City of San Antonio
TRANSPORTATION AND CAPITAL IMPROVEMENTS

ADDENDUM NO. 4

PROJECT NAME: **Ray Ellison (Loop 410 to Old Pearsall Road)**

PROJECT NO.: **40-00312**

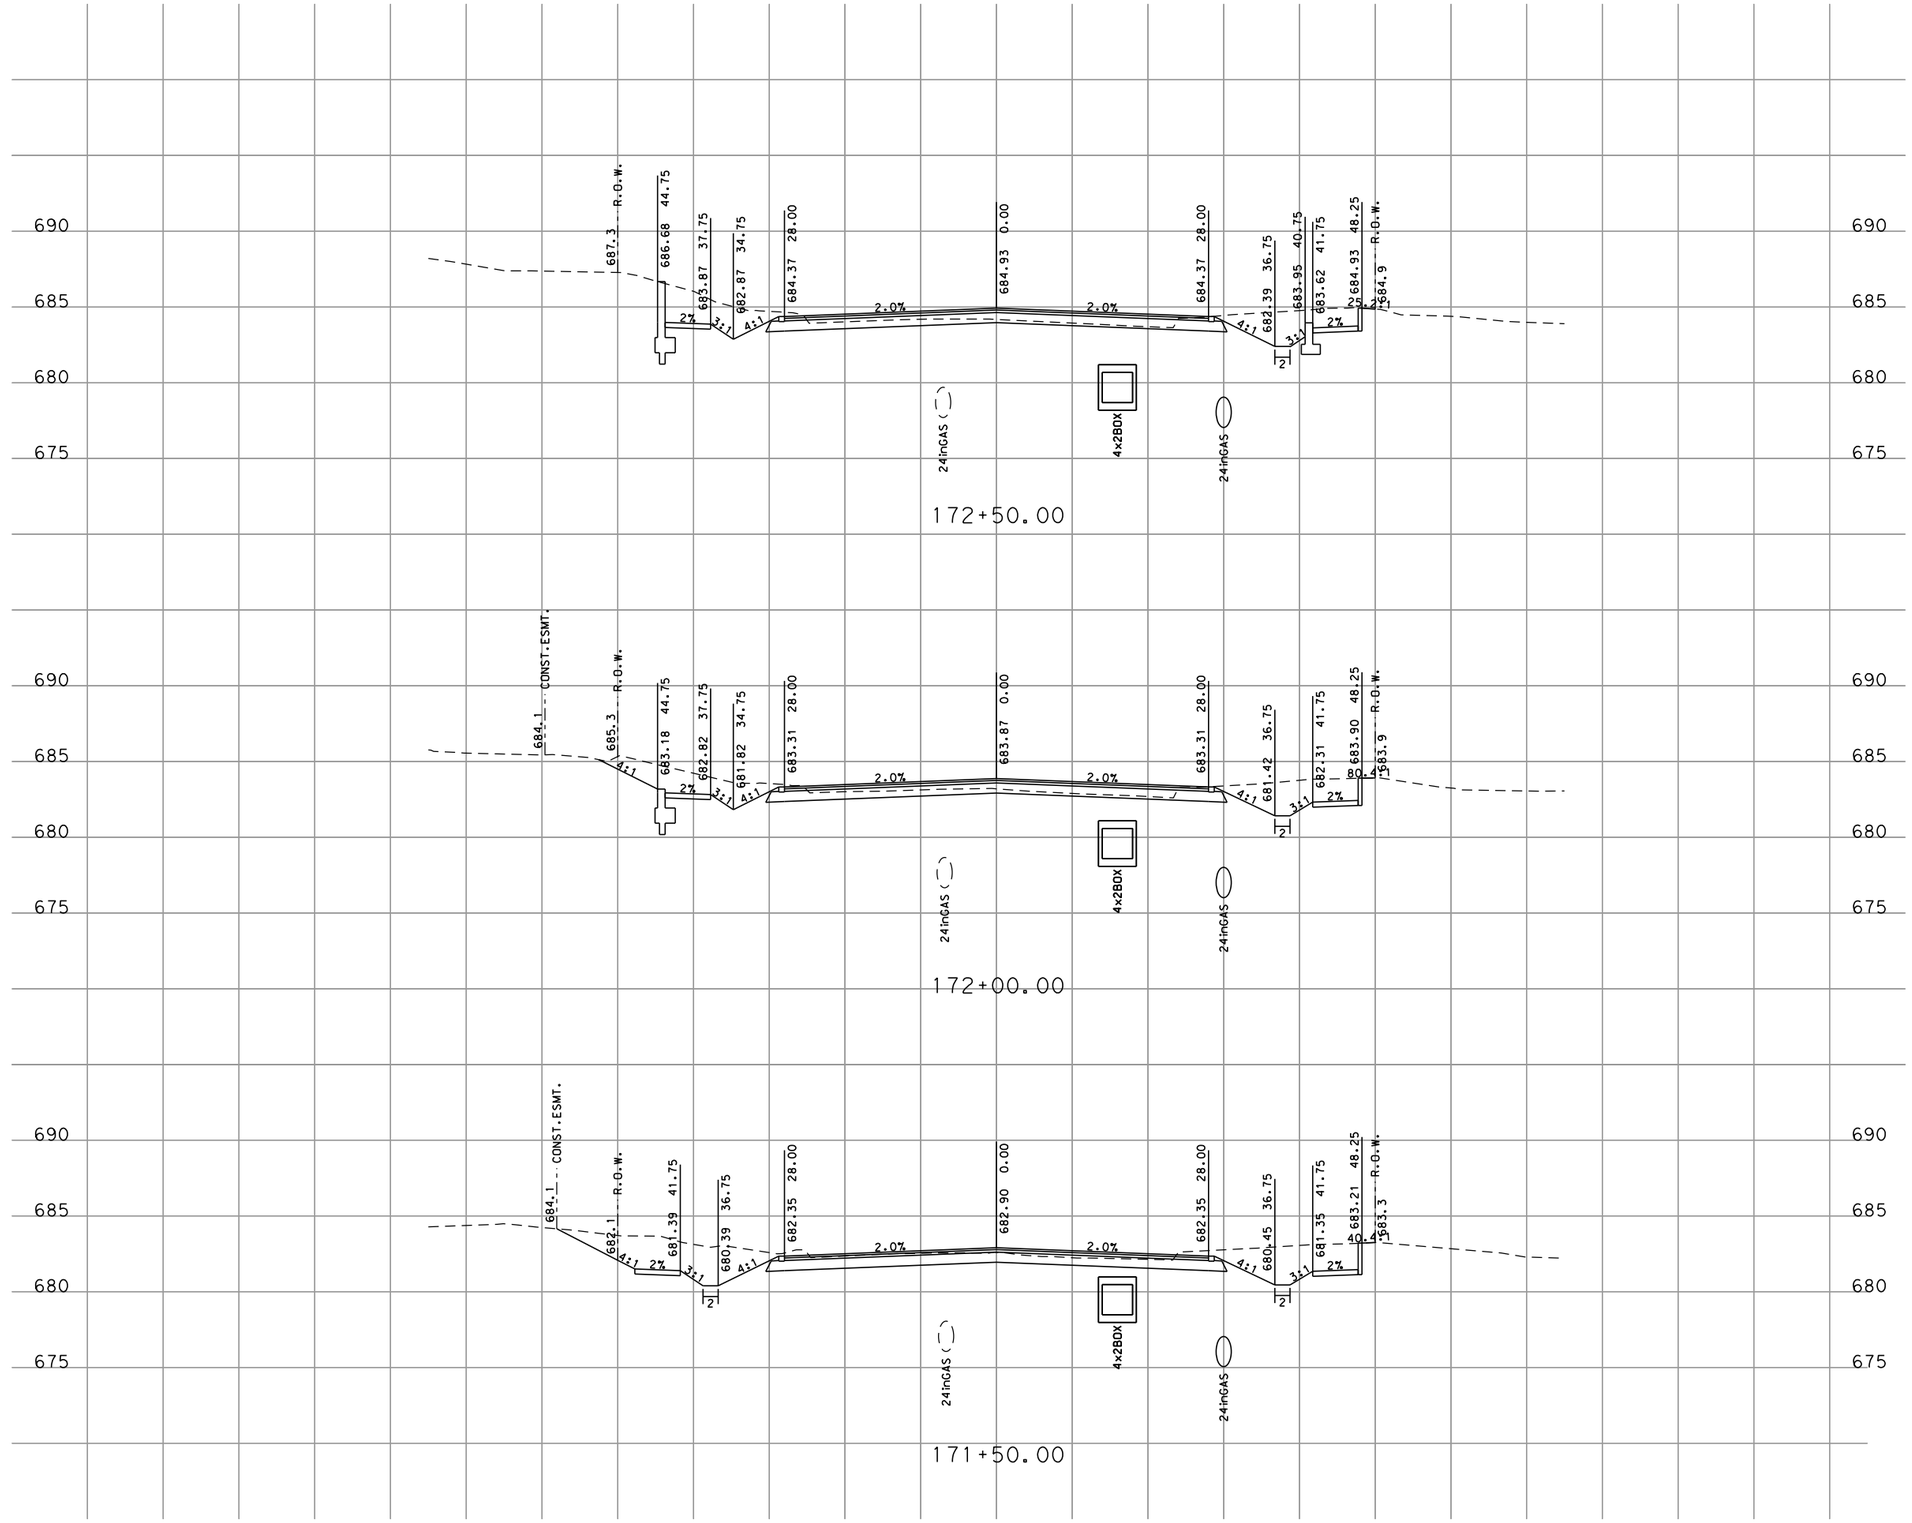
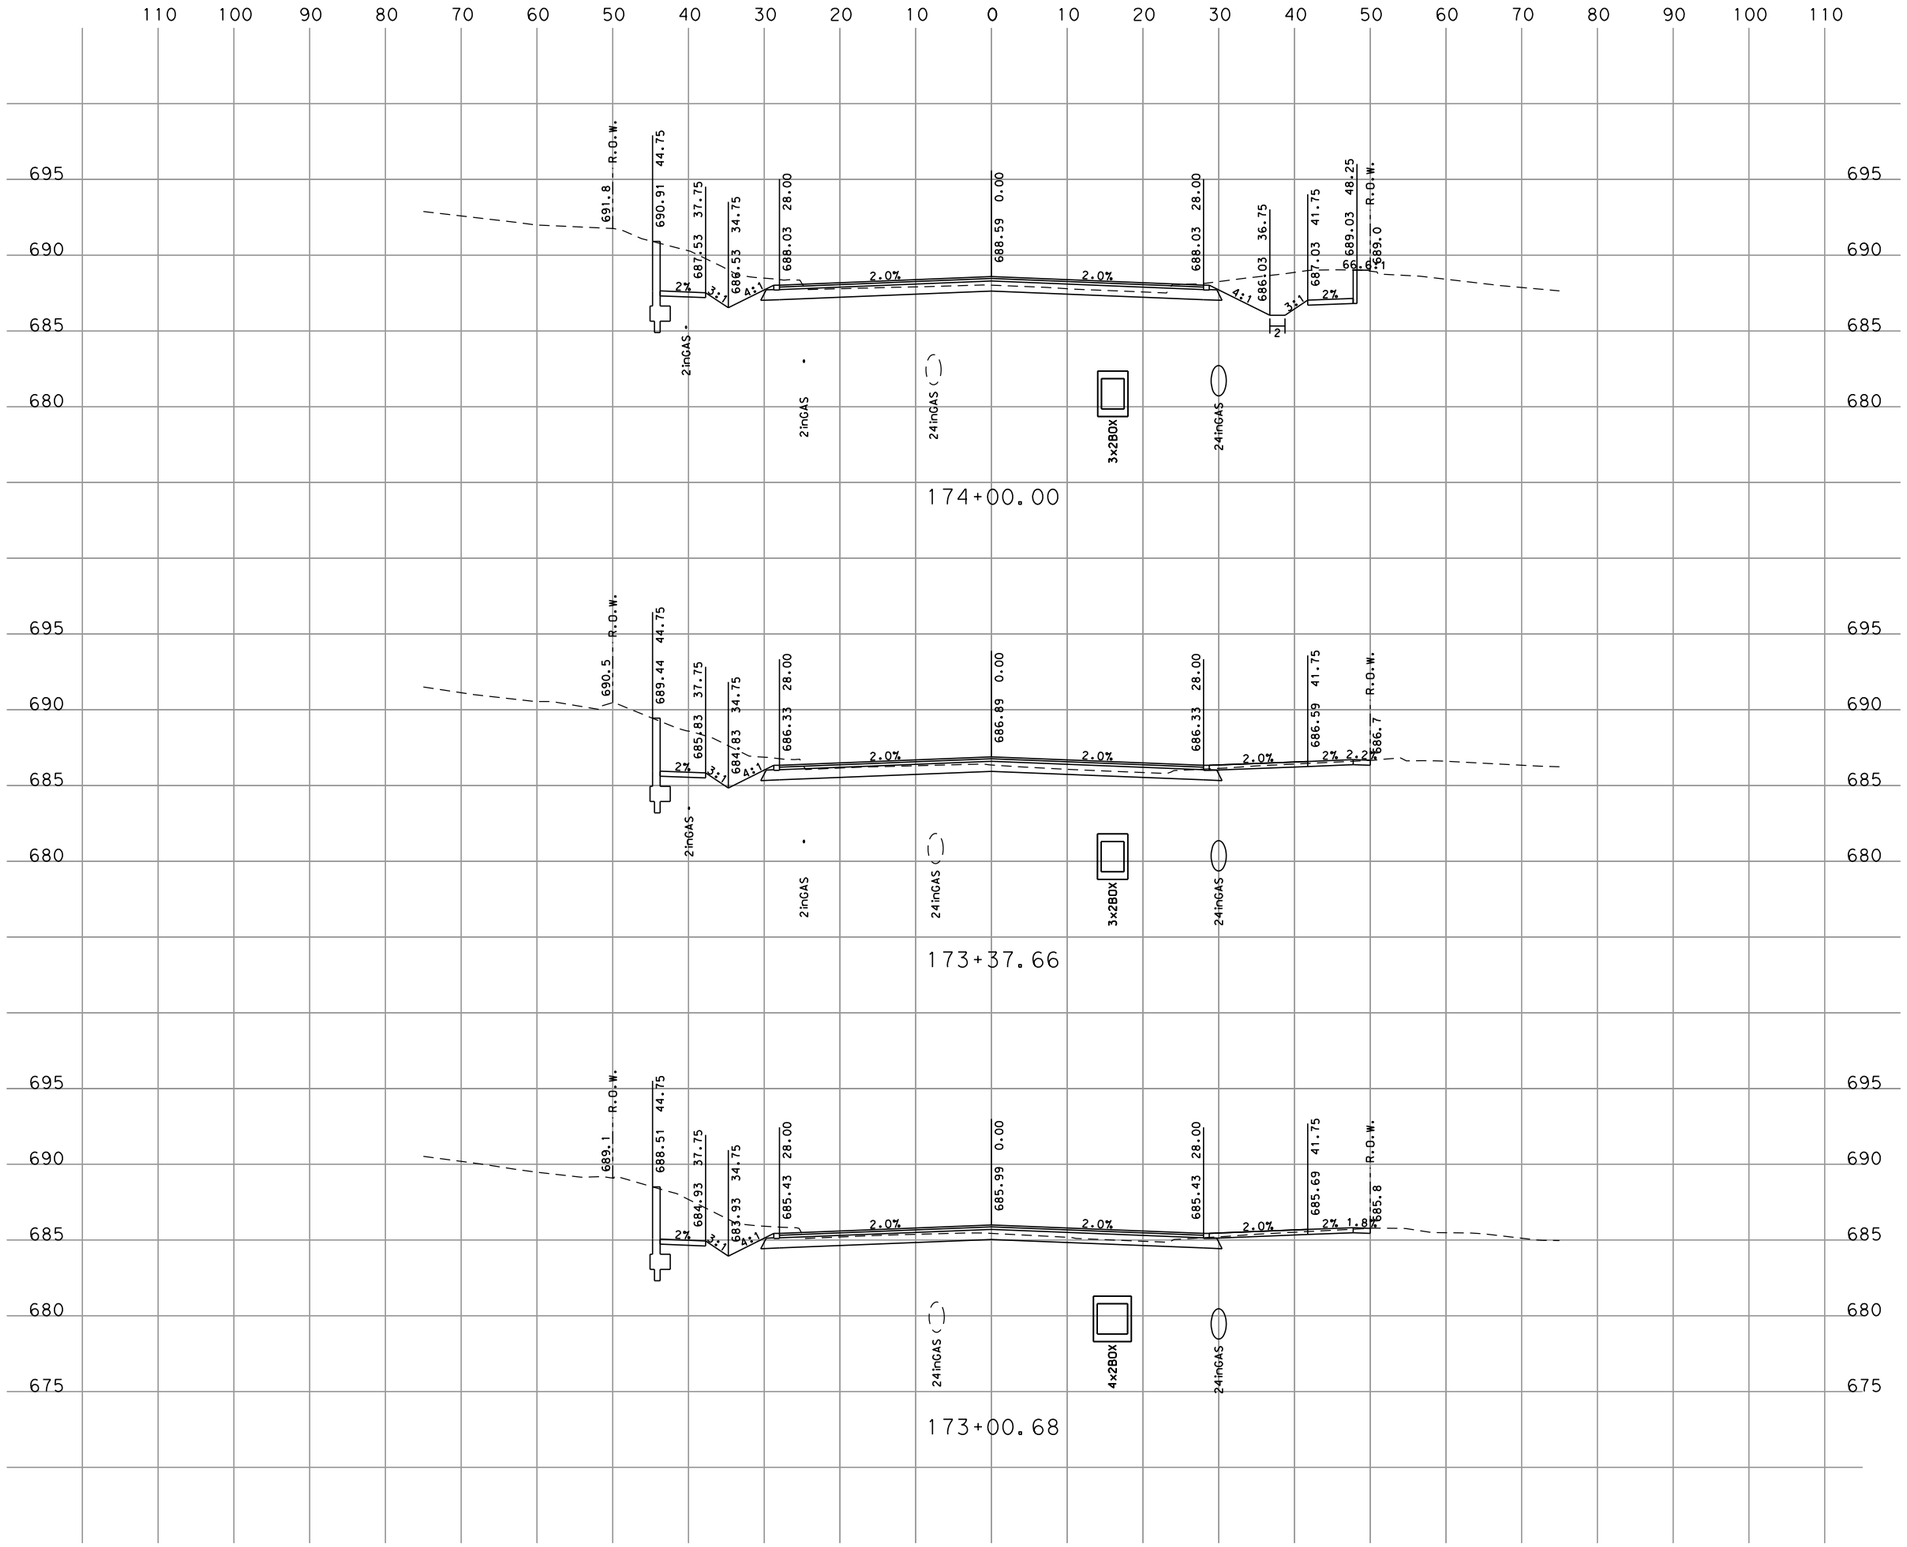
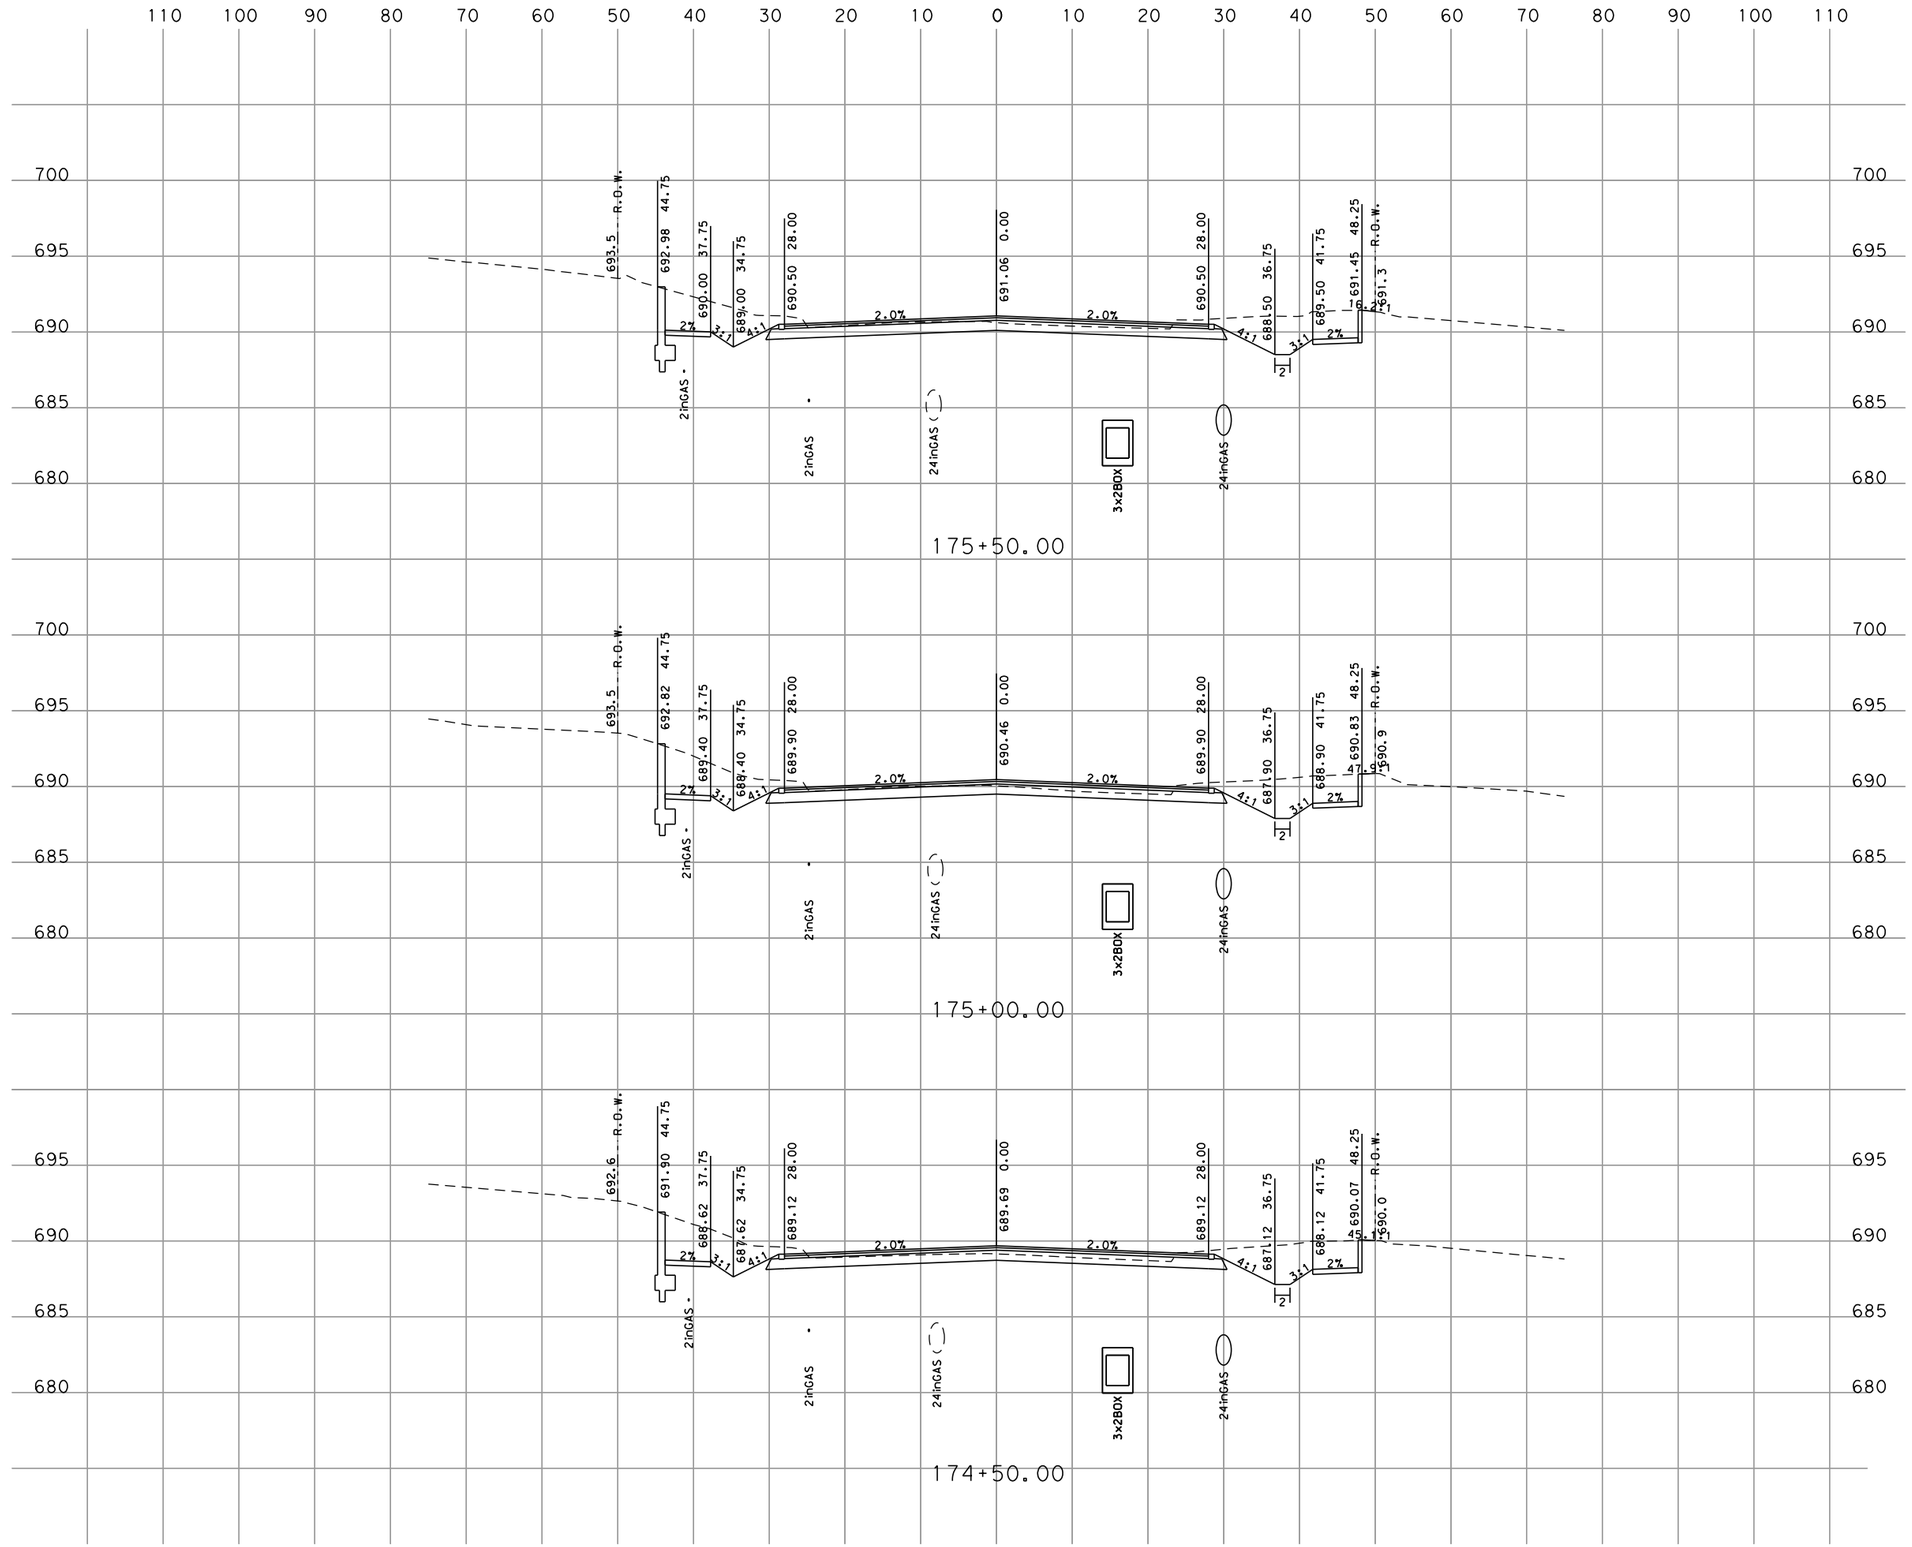
- Replace Sheet L2.2 “Planting Details and Plant Lists” with Addendum No. 4 Sheet L2.2 “Planting Details and Plant Lists.” Revised plants.
- Replace Sheet 394 “Proposed Cross Sections” with Addendum No. 4 Sheet 394 “Proposed Cross Sections” Revised retaining wall and sidewalk.

- Replace Sheet 395 “Proposed Cross Sections” with Addendum No. 4 Sheet 395 “Proposed Cross Sections” Revised retaining wall and sidewalk.
- Replace Sheet 396 “Proposed Cross Sections” with Addendum No. 4 Sheet 396 “Proposed Cross Sections” Revised retaining wall and sidewalk.

- Replace Sheet 397 “Proposed Cross Sections” with Addendum No. 4 Sheet 397 “Proposed Cross Sections” Revised retaining wall and sidewalk.
